NORTH MACADAM DISTRICT STREET PLAN IMPLEMENTATION AMENDMENTS

Ordinance No. 171522

**Amendments to: the Zoning Code, Willamette
Greenway Plan, and the Design Guidelines for the
North Macadam District of the Central City Plan**

Map 510-3 Maximum Heights

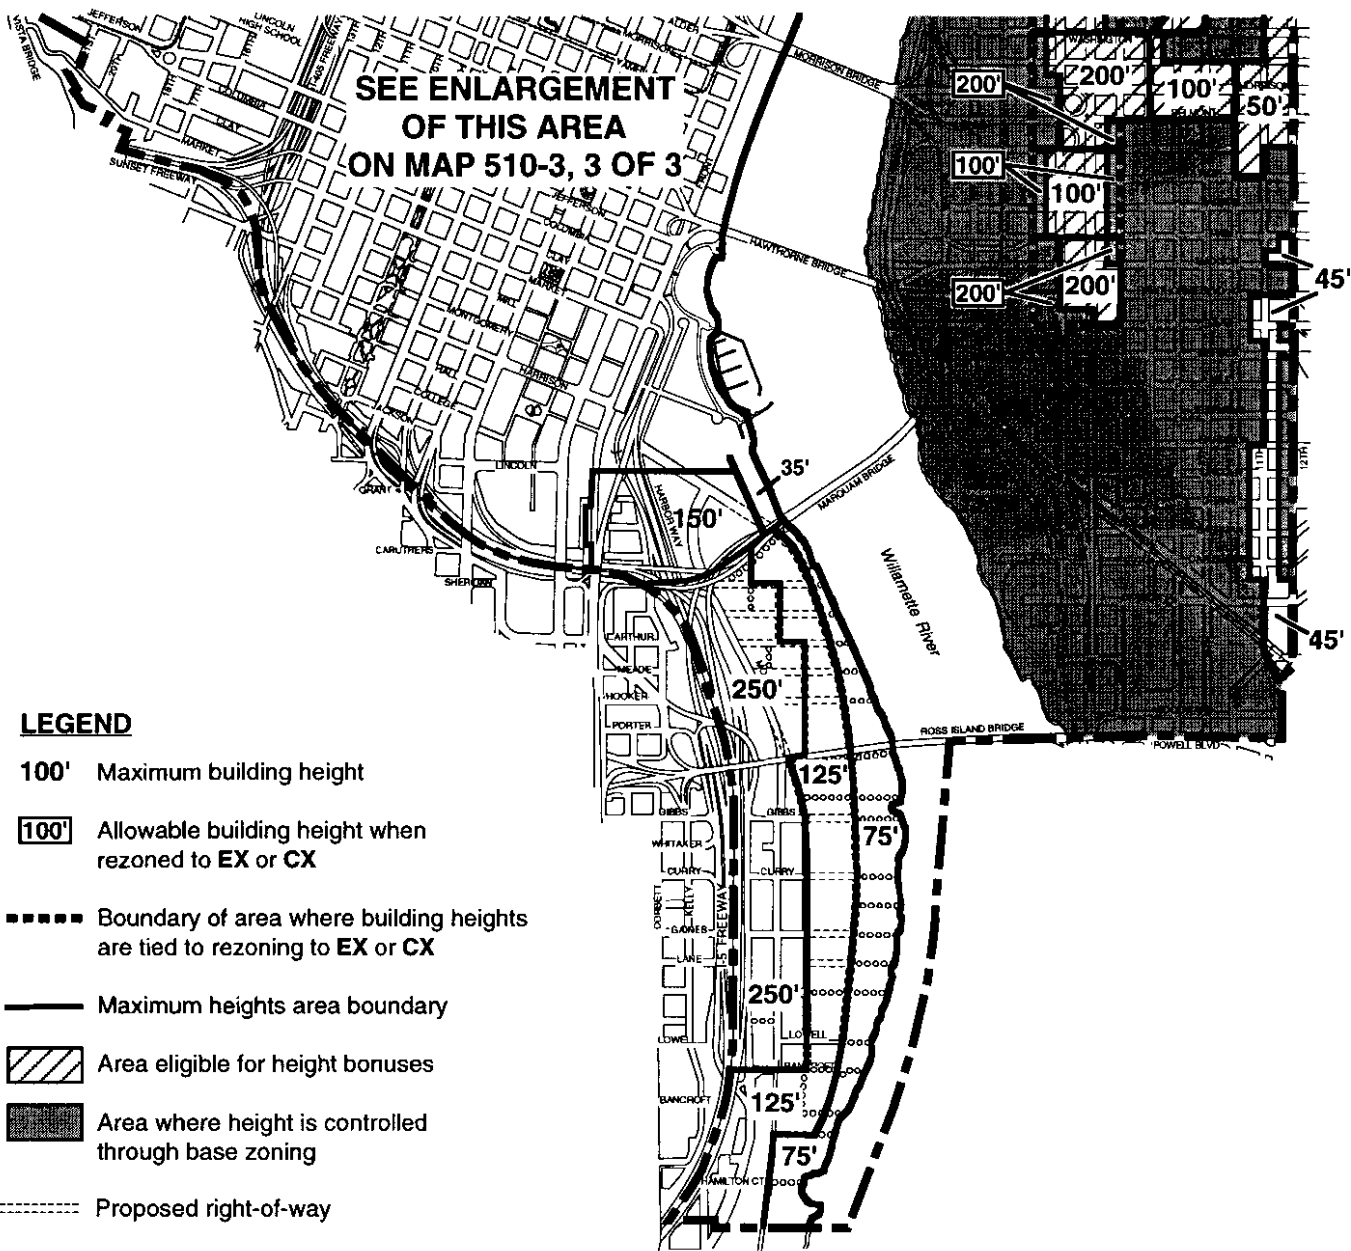
Staff evaluated existing maximum building heights in the North Macadam District with the accepted district street plan. This was done to identify any changes to boundary lines given the new street network configuration.

Maximum building height boundaries correlate with the Maximum FAR boundaries. FAR and building heights are two key standards that collectively guide the bulk and massing of buildings.

Staff reviewed maximum building heights as part of a step-down approach to intensity as identified in the Central City Plan and the Special Design Guidelines for the North Macadam District. The adopted maximum building heights will allow the tallest buildings next to Interstate-5 and the proposed South-North Light Rail line (a maximum of 250 feet), transitioning to medium-rise buildings in the center of the district (a maximum of 125 feet) and then to low-rise building heights (a maximum of 75 feet) closest to the Willamette River Greenway. This is consistent with the goals, objectives and policies of the Special Design Guidelines for the North Macadam District. It is also supportive of future Light Rail Transit which may locate along the SW Moody Avenue corridor.

Map 510-4

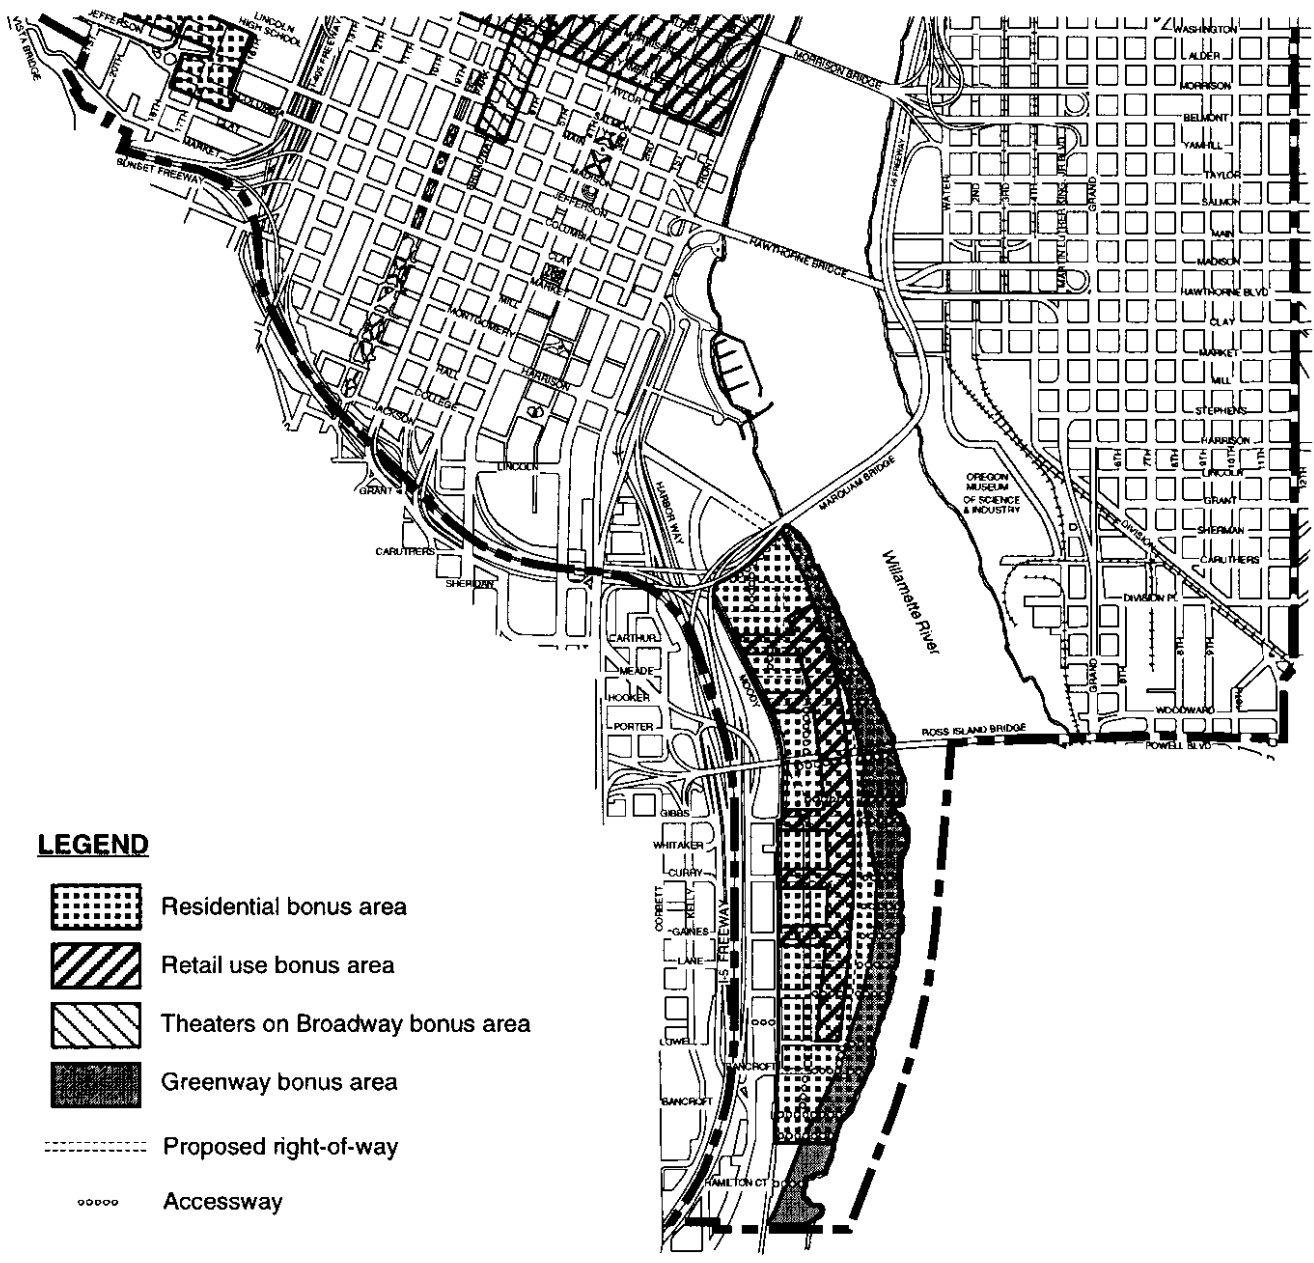
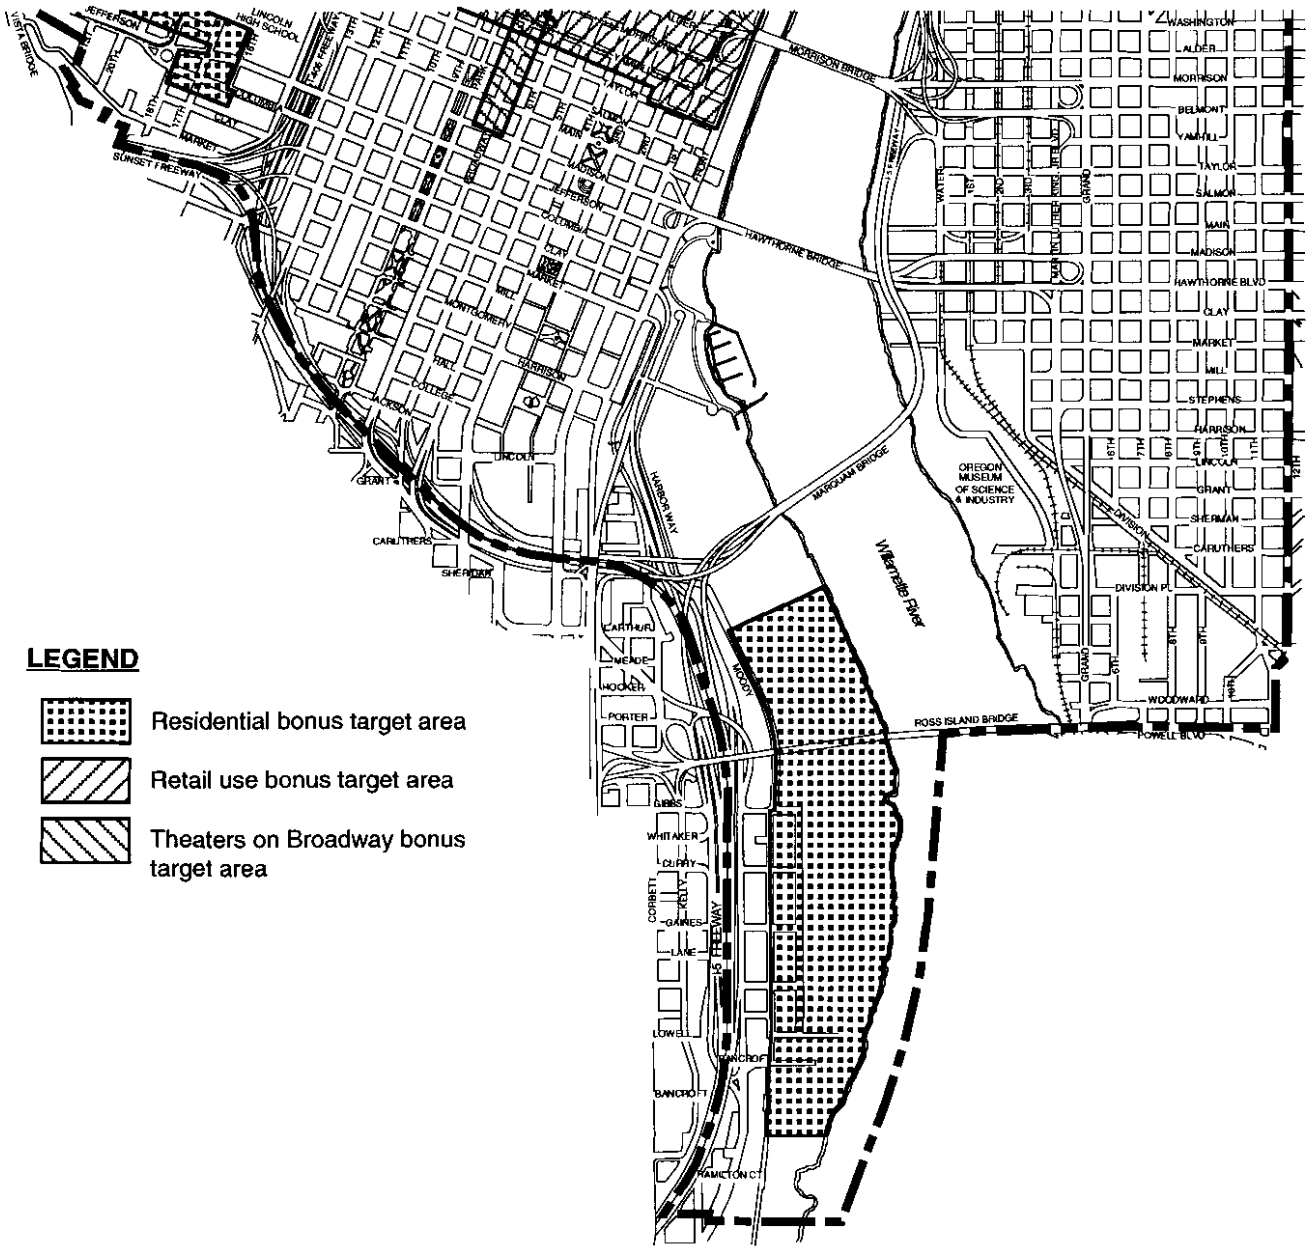
This City Council adopted amendment applies a Retail Bonus Option Area to properties that are adjacent to the west side of the River Parkway right-of-way and along some east-west streets: Arthur, Hooker, Gibbs, Curry and Gaines. This is to encourage local pedestrian activity through the provision of retail services and to reduce unnecessary automobile trips to other destinations for similar goods and services.

There is a bonus option for retail uses in the North Macadam District will provide an incentive for developers to include retail uses in their projects. These uses are not mandated and do not affect the full development potential of the other proposed uses on a particular site. The bonus can be selected in locations which market demand analysis indicates can support such uses.

The west side of River Parkway is identified for the retail bonus option instead of both sides of the parkway because of the parkway's proximity to the Willamette River Greenway to the east and the likelihood for single-use residential developments locating on the east side of River Parkway. The east-west streets depicted with the retail use bonus option are planned to be primary east-west pedestrian-active streets in the district.

Map 510-6

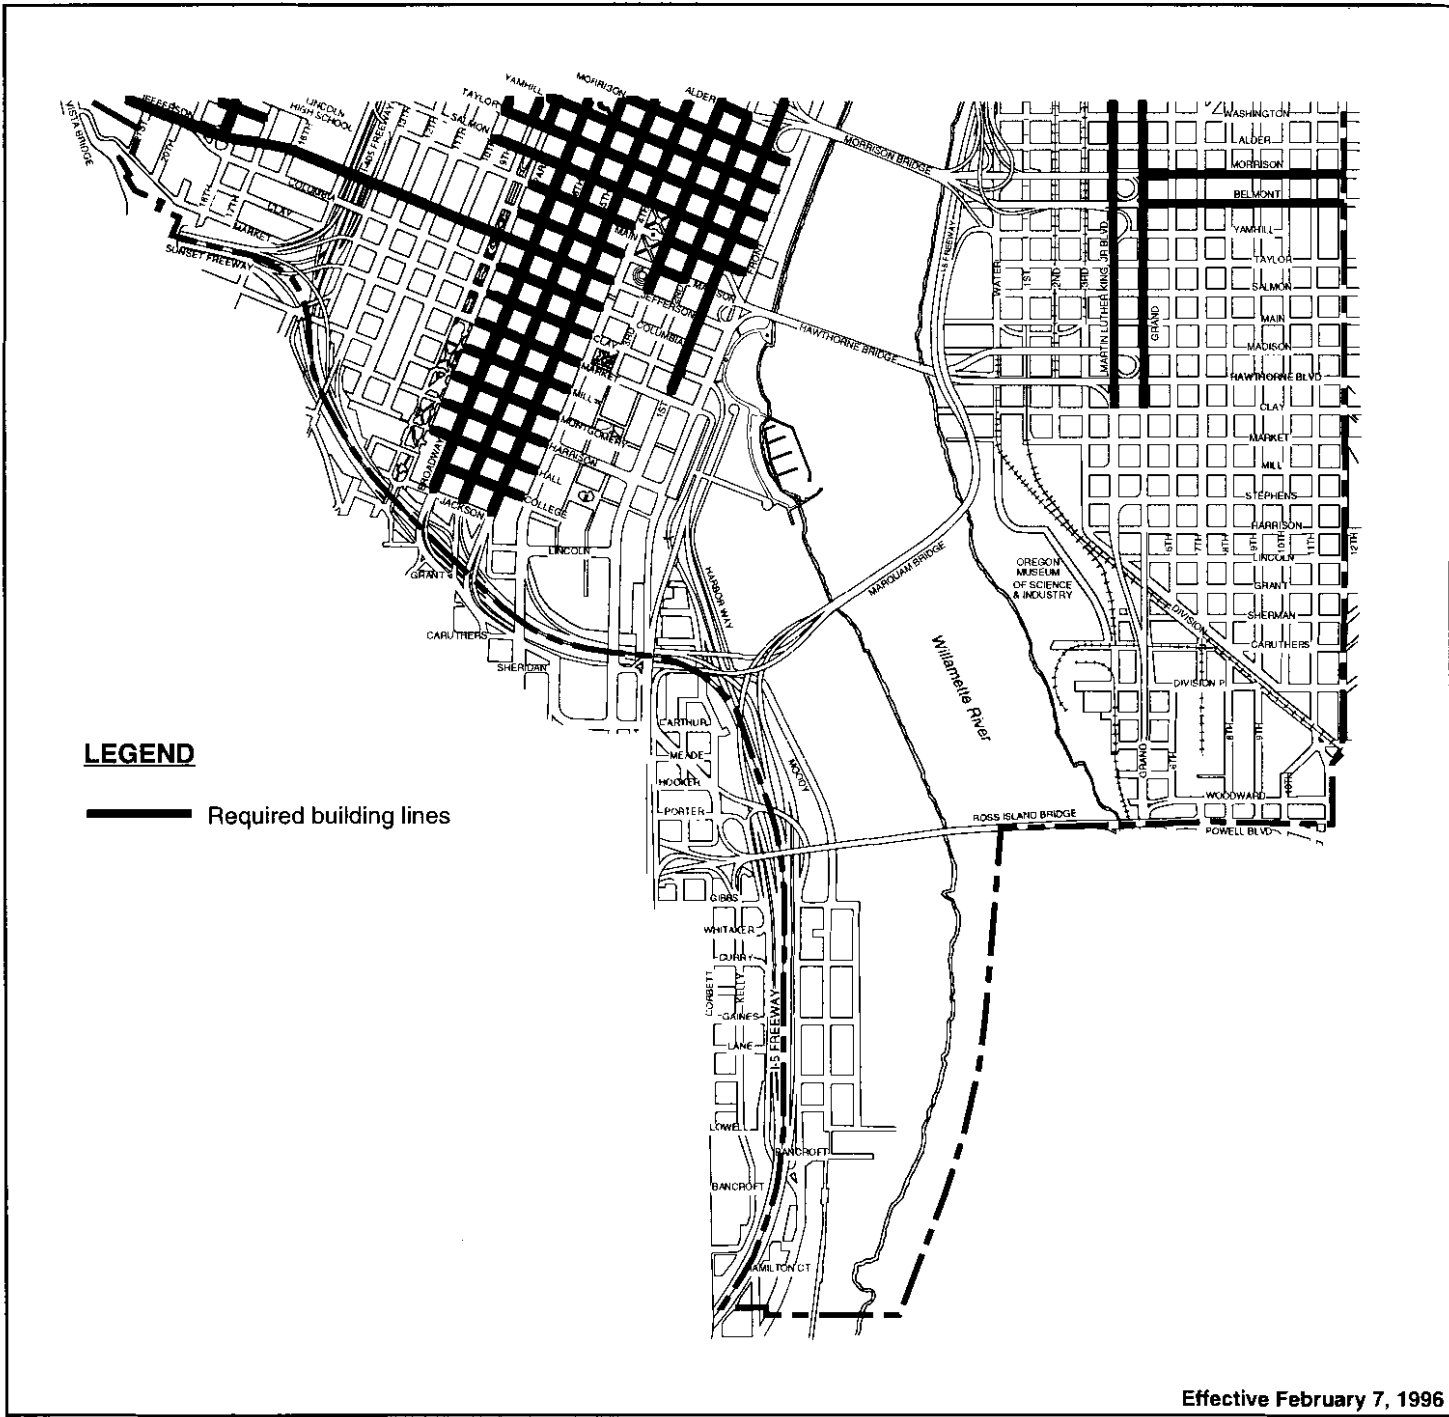
The City Council approved the application of the Required Building Lines standard to new developments which front a number of north-south and east-west streets in the North Macadam District. Required building lines are intended to make buildings locate at or near the front property line, creating pedestrian-accessible active use areas between the building and the street in an urban setting. This is reflected in a revised Map 510-6. The text for Section 33.510.215.D, Building Line Standards, can be found in the Appendix of this report.

The streets identified with Required Building Lines in the North Macadam District are those which are key north-south and east-west corridors in the district for commercial, office, retail and other uses which encourage street level pedestrian activity. According to the street plan, many of these transportation corridors are planned for an enhanced pedestrian environment and will have multi-modal access including transit, and limitations on parking lot access. The building line standard is applied to numerous streets in the Central City Core area which has similar street classifications to the streets with this requirement in the North Macadam District.
